Questions & Answers

NEC Fuel Dispensing Project

S-IZ100-12-R-0011

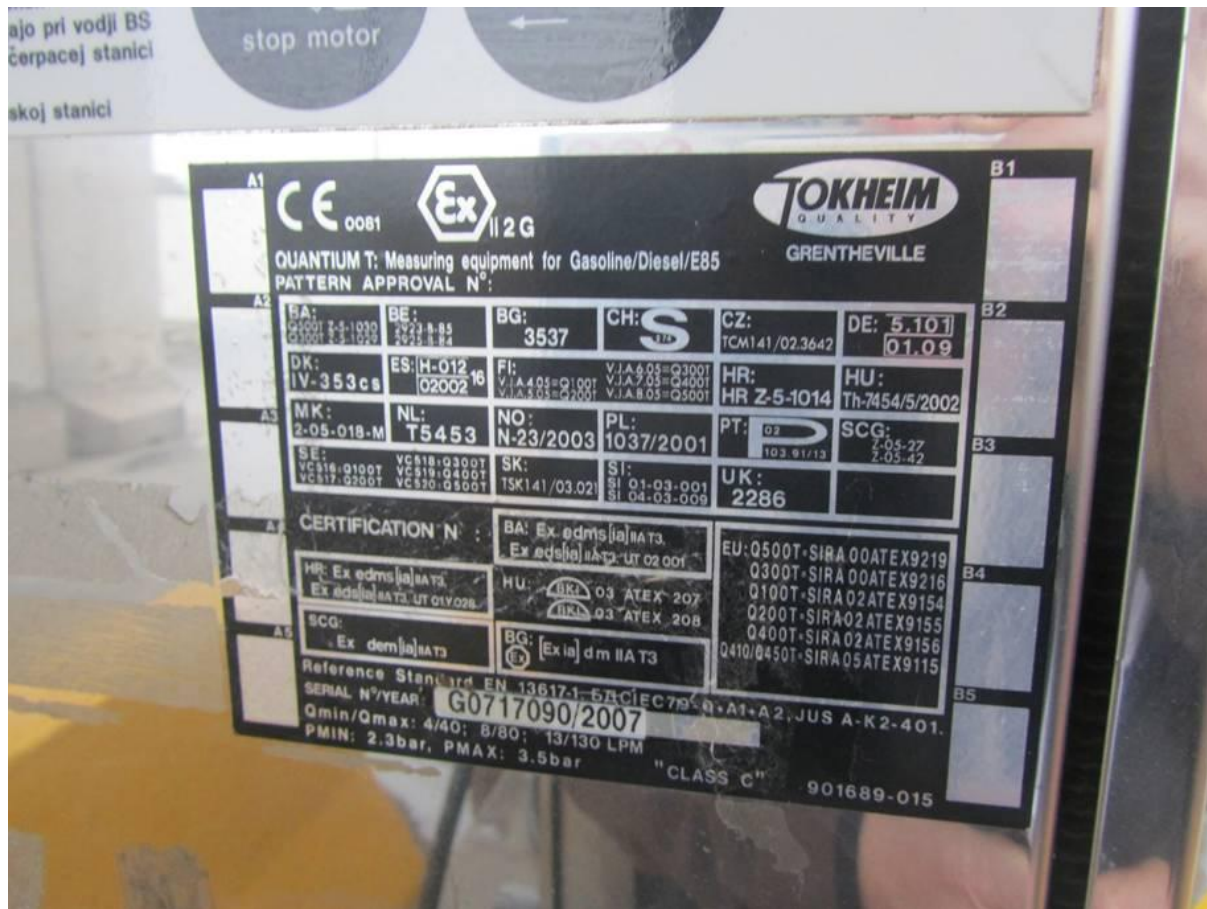
Question: Would you please provide the Manufacturer Brand name and MFR model for the existing fuel dispensing pumps.

Answer: The existing dispensing pumps are manufactured by Tokheim. From the pump nameplate: Quantum T: Measuring equipment for Gasoline/Diesel/E85. Serial number: G0717090, installed 2007. Photo below.
